PLANT NAME: OCONEE # 1, 2 & 3

ADDITIONAL INFORMATION CONCERNING THE SEISMIC
DESIGN FO THE OVERHEAD EMERGENCY POWER PATCH
THROUGH THE 230 KV SWITCHYARD..... W/DRAWINGS

OCONEE NUCLEAR STATION
SEISMIC CAPABILITY OF EMERGENCY POWER PATH
REQUEST FOR ADDITIONAL INFORMATION

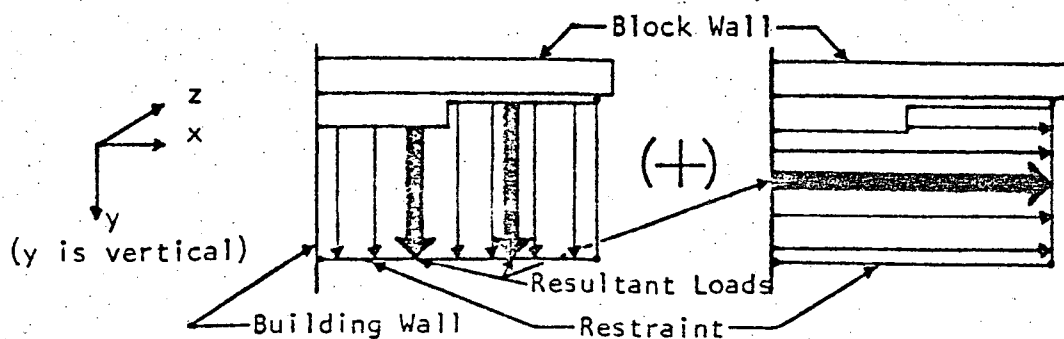
- a. State whether the analysis method was static or dynamic, and justify your selection.
- b. Provide a diagram of the math model used for each equipment item.
- c. Provide input loads used in the analysis and point of application.
- d. Show location and magnitude of the highest stress intensity and deflection, and list the corresponding margins of safety.
- e. Verify that the operability of each equipment item was considered in your analysis and provide a discussion on how the calculated deflections were considered in relation to the operability of the component.
- f. Define the acceptance criteria used in the operability analysis.

- a) HVAC Duct System - The duct was modeled as a simple beam between supports providing similar restraint directions. Typical supports and their corresponding restraint directions are shown below.

Supports were located at each duct joint to limit spans (and deflections) and to assure the integrity of the joint connection. Using this simple beam model and the static approach, seismic hanger loads were calculated, and the designed restraints were analyzed.

FIGURE 1. SF-6 GAS CIRCUIT BREAKER ASSEMBLY

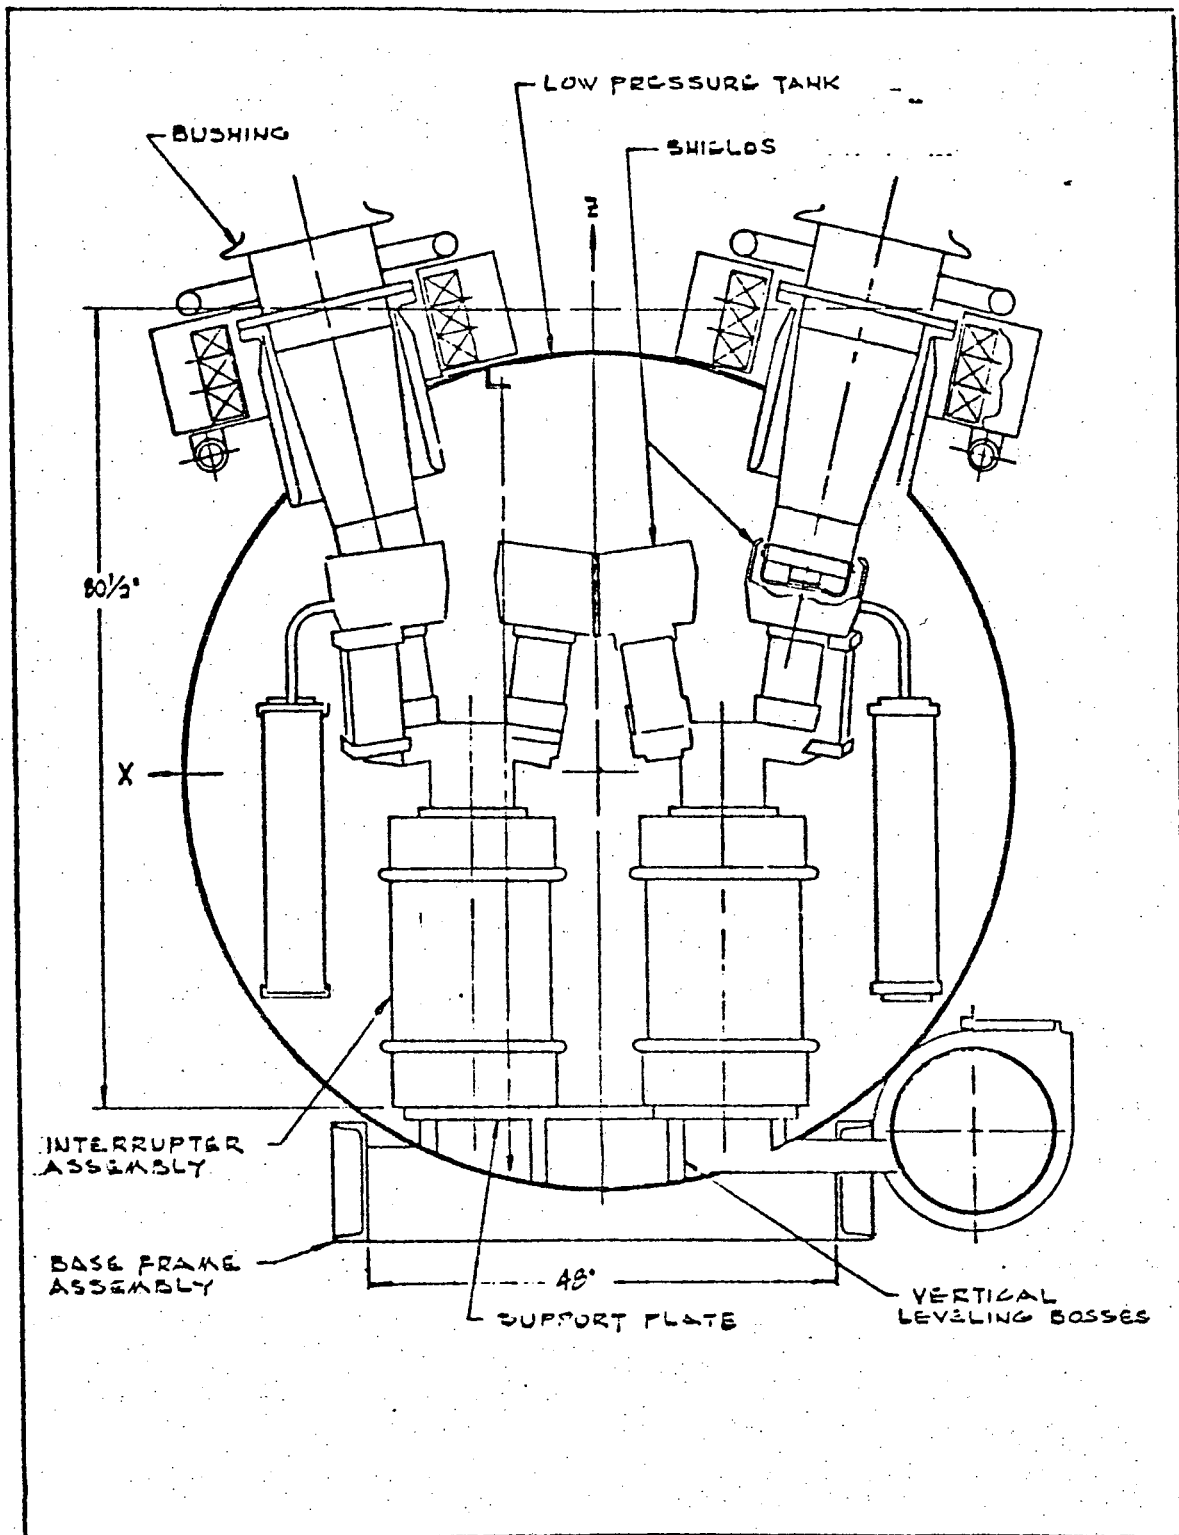
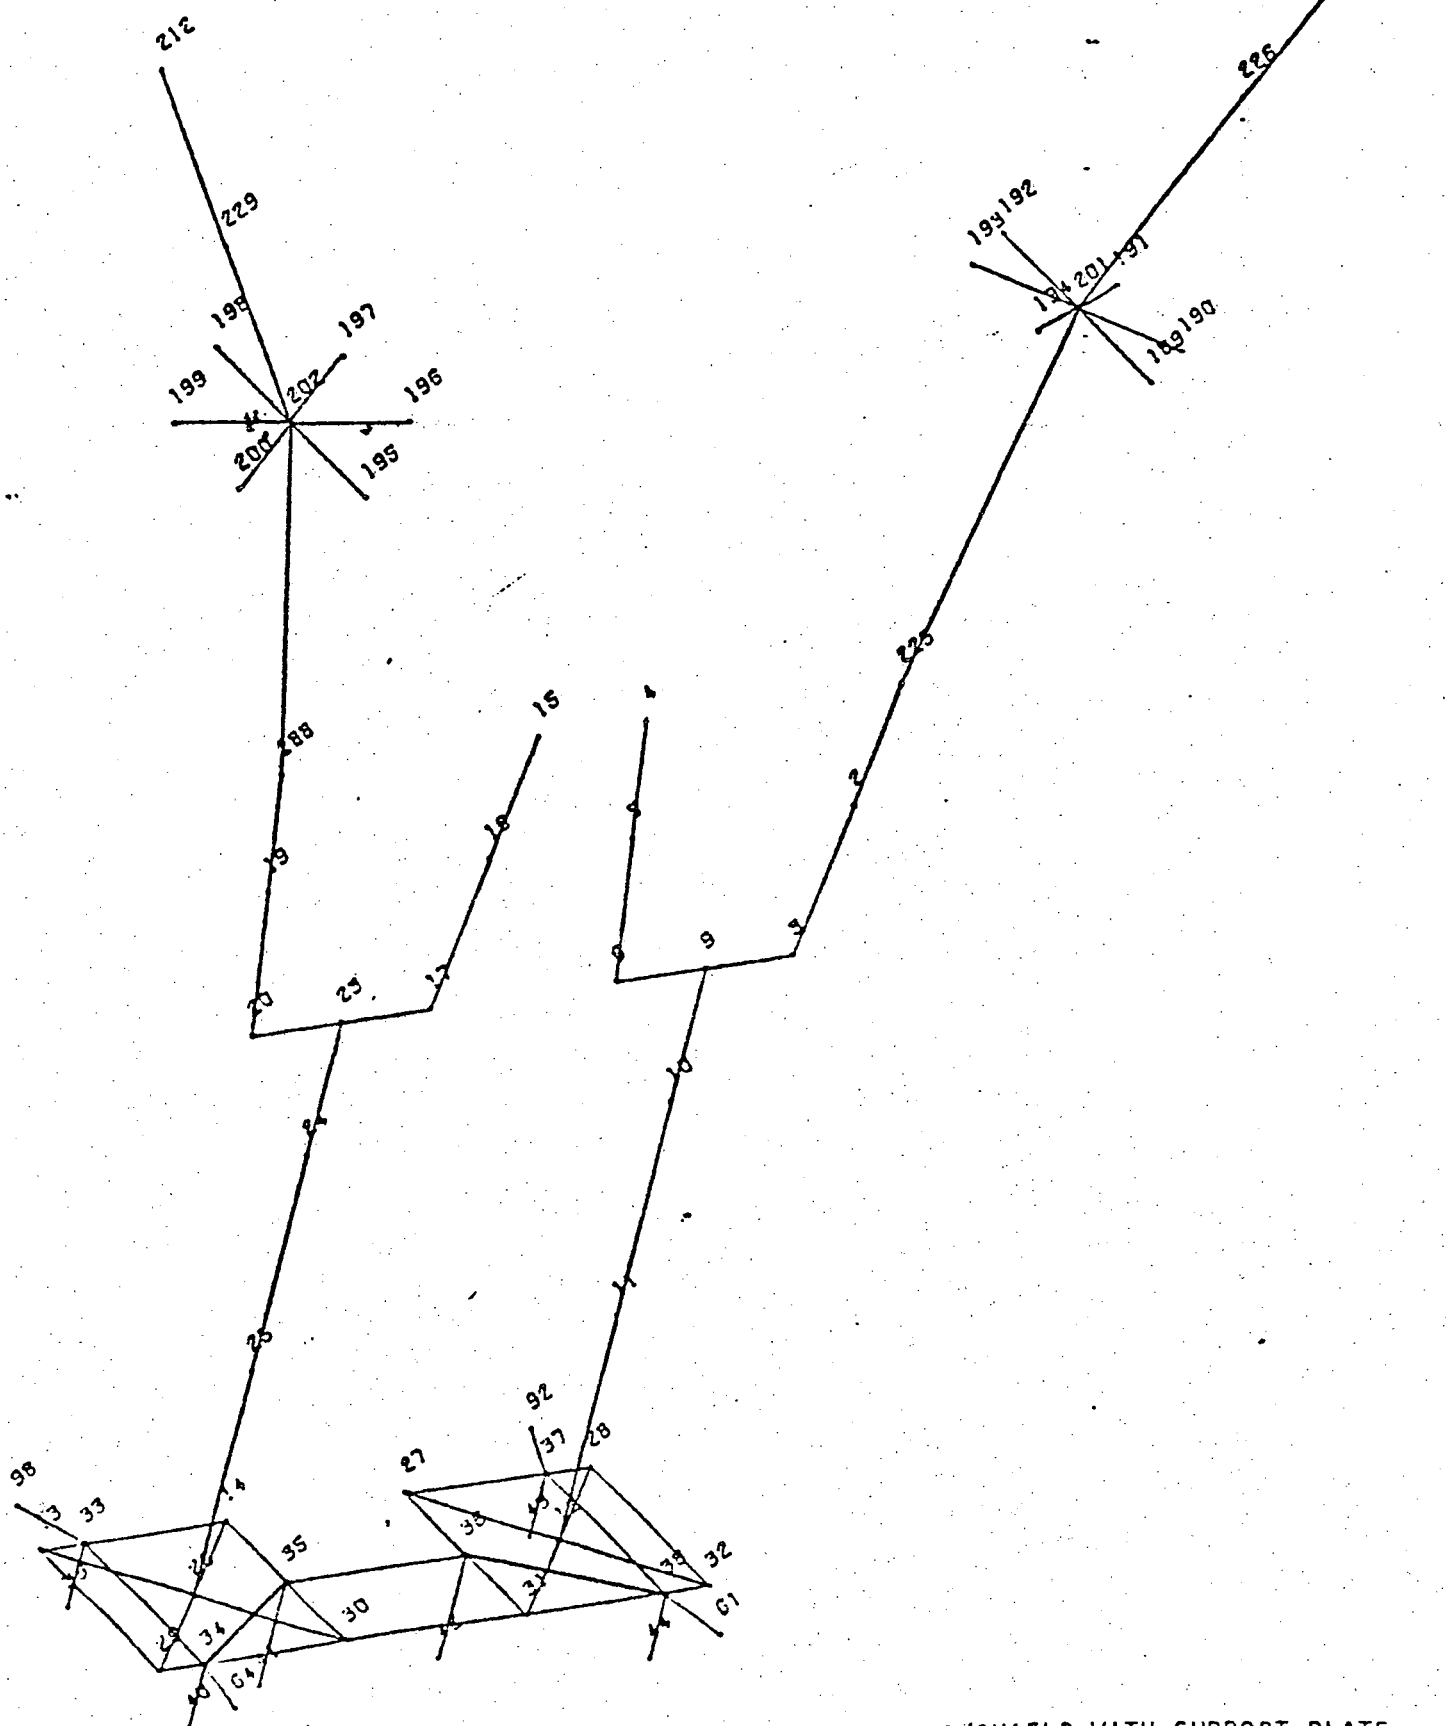
On Table II, identify clearly, for each of the items qualified by a combination of test and analysis, the portions which were qualified by analyses, and the portions which were qualified by tests. Provide some typical results for the qualification program for the 230kV Power Circuit Breakers (PCB) and supportive equipment.

- Note I: The PCB's were analyzed using a dynamic finite element analysis with both a simplified model of the entire breaker and a detailed model of one tank assembly. A description of the analysis is contained in the Agbabian Associates' Report M-7242-2619. (Figures 1, 3, and 5 of this report are included at the end of these notes.) Low level testing was also used to verify the results of the analysis. Operability of the equipment under seismic loads was not considered in this analysis; however, the structural integrity of the breakers was ensured.
